Appendix E – Watercourse Crossing Details

Candwr Solar Farm
Ponthir, NP18 1HU

Appendix F – Monmouthshire County Council Ordinary Watercourse Advice

Flood and Water Management Act 2010 (Schedule 3) – Sustainable Drainage – Pre-Application Advice Report

Location Plan:

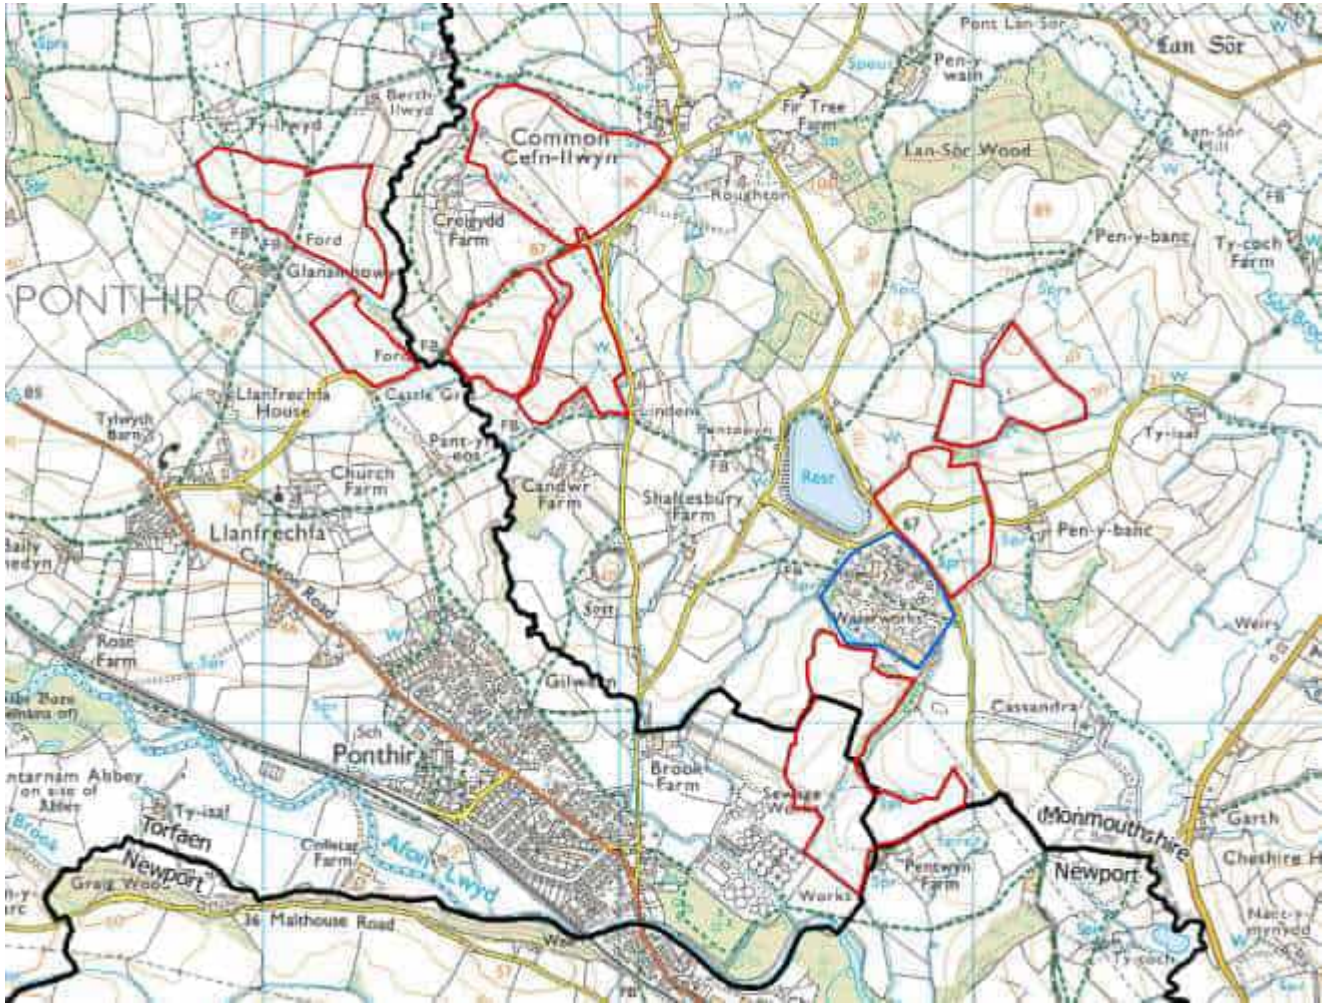
The site is a proposed solar farm with associated infrastructure such as inverters, transformers, substation, and access roads. The total site is large (approximately 76.5 ha) and lies between Torfaen (23.2 ha) and Monmouthshire (53.3 ha) SAB areas.
